PIC16C923 Rev. A Silicon/Data Sheet Errata

The PIC16C923 (Rev. A) parts you have received conform functionally to the Device Data Sheet (DS30444E), except for the anomalies described below.

FIGURE 1: SCK PULSE VARIATION USING TIMER 2/2

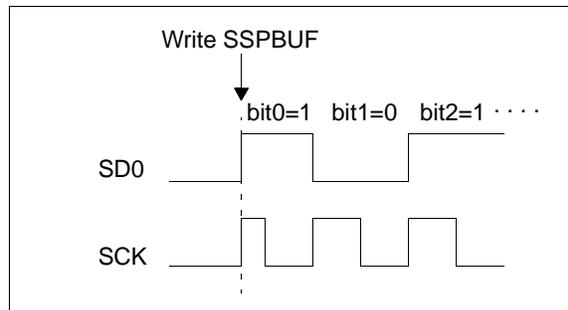
When the SPI is using Timer2/2 as the clock source, a shorter-than-expected SCK pulse may occur on the first bit of the transmitted/received data (see Figure 1).

To avoid producing the short pulse, turn off Timer2 and clear the TMR2 register, load the SSPBUF with the data to transmit, and then turn Timer2 back on. Refer to Example 2 for sample code.

FIGURE 1: WRITES TO TIMER1 (EXTERNAL CLOCK/OSCILLATOR MODE)

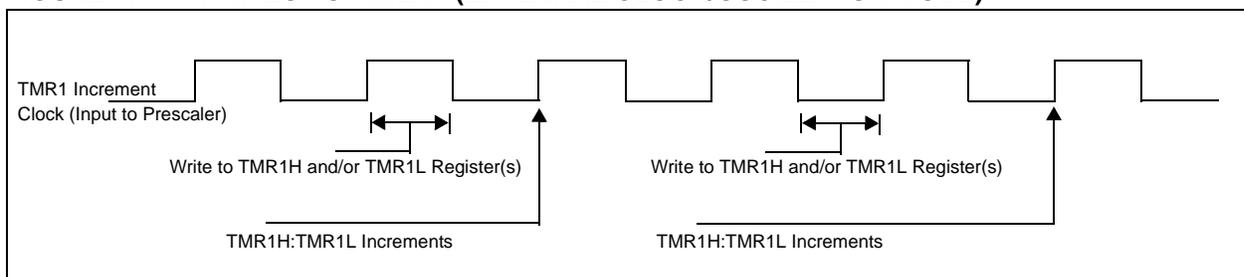
The operation of Timer1 needs some clarification when the timer registers are written and the TMR1ON bit is set.

The internal clock signal that is the input to the TMR1 prescaler affects the incrementing of Timer1 (TMR1H:TMR1L registers and the Timer1 prescaler). When the Timer1 registers are NOT written, the Timer1 will increment on the rising edge of the TMR1 increment clock.

When the TMR1H and/or TMR1L registers are written while this clock is high, TMR1 will increment on the next rising edge of this clock.

When the TMR1H and/or TMR1L registers are written while this clock is low, TMR1 will not increment on the next rising edge of this clock, but must first have a falling clock and then the rising clock for TMR1 to increment.

Figure 1 shows the two cases of writes to the TMR1H and/or TMR1L registers. Due to the V_{IH} and V_{IL} thresholds on the oscillator/clock pins, external Timer1 oscillator components, and external clock frequency, the Timer1 increment clock may not be of a 50% duty cycle.

The TMR1 increment clock is out of phase of the T1OSO/T1CKI pin by a small propagation delay.

FIGURE 2: PORTC BLOCK DIAGRAM (PERIPHERAL OUTPUT OVERRIDE)

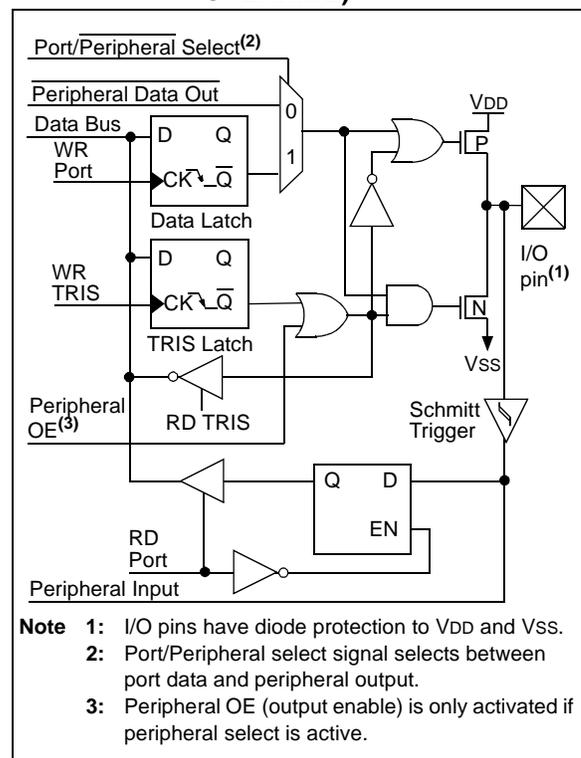
The block diagram for PORTC presented in Figure 5-5 of the Device Data Sheet (DS30444E) is incorrect. The correct block diagram is shown in Figure 2.

FIGURE 3: WAVEFORMS IN 1/2 MUX, 1/3 BIAS DRIVE

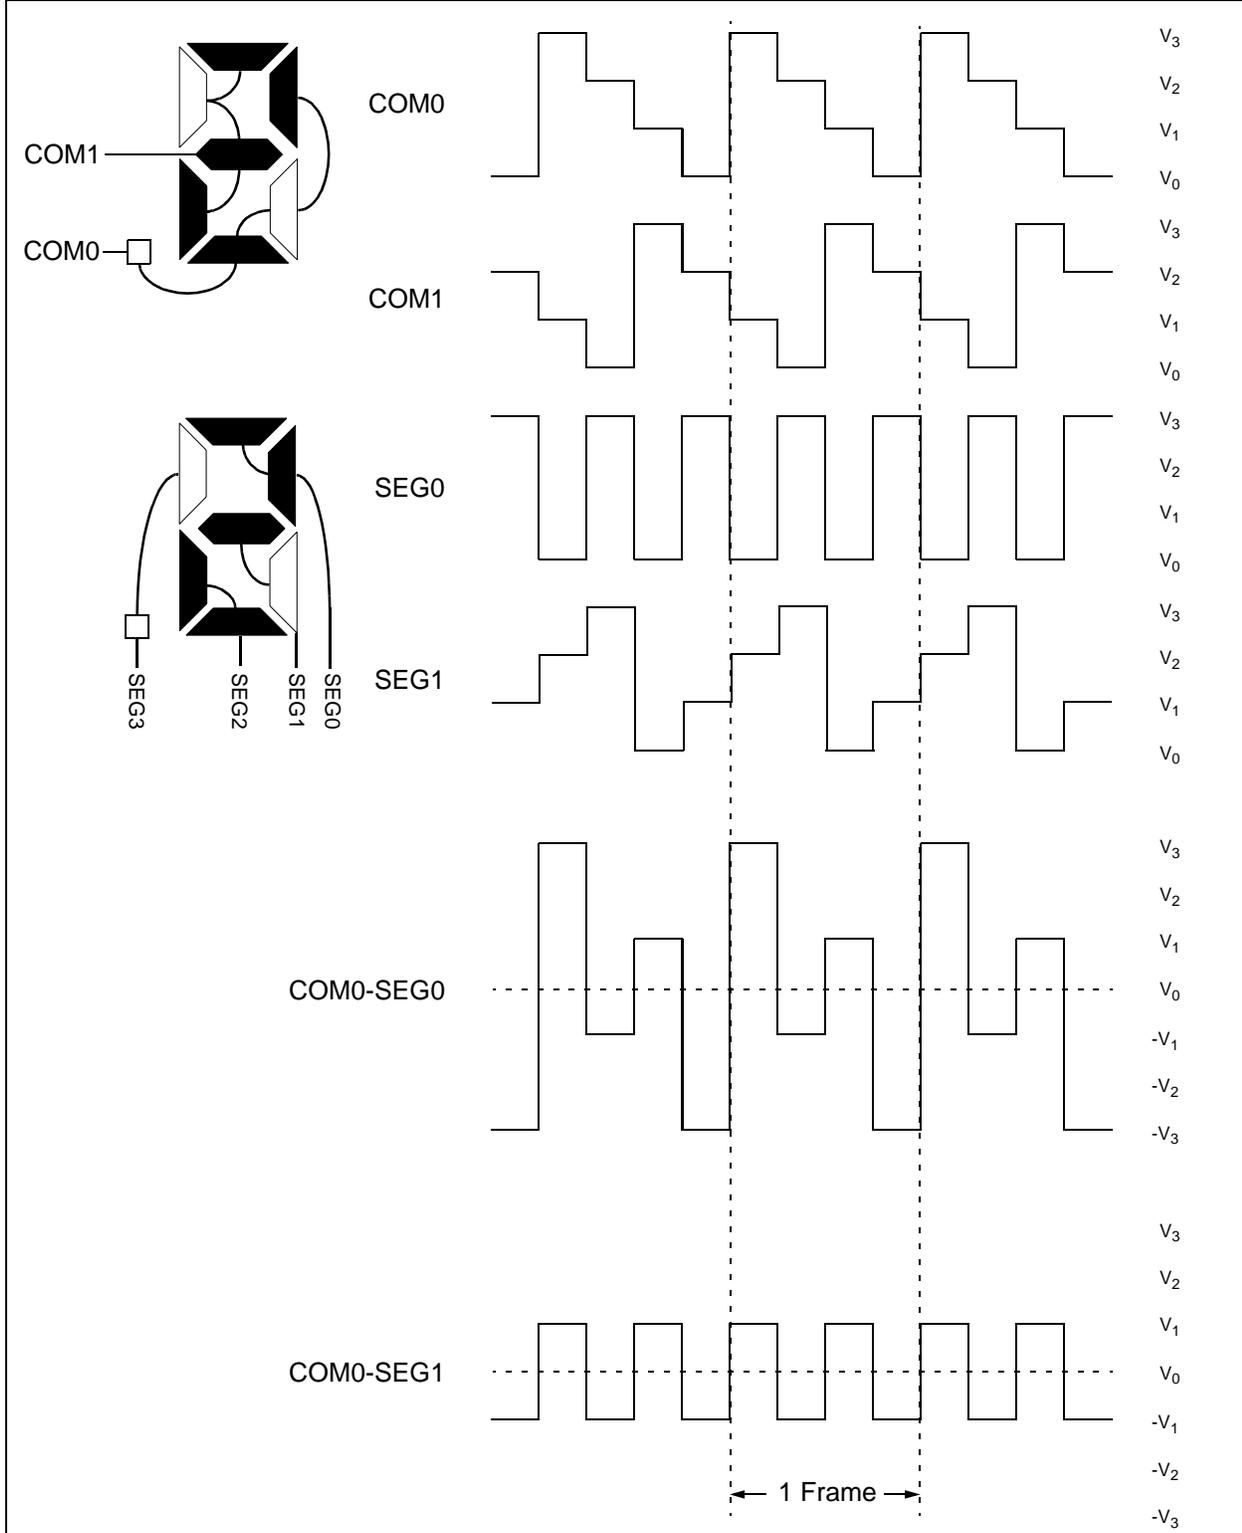
Figure 13-5 in the data sheet, depicting drive waveforms in 1/2 multiplex, 1/3 bias mode, is incorrect. Specifically, the connections for the

different LCD segments (SEG0 through SEG4) and the SEG1 drive waveform have been changed. The correct diagrams and waveforms are shown in Figure 3.
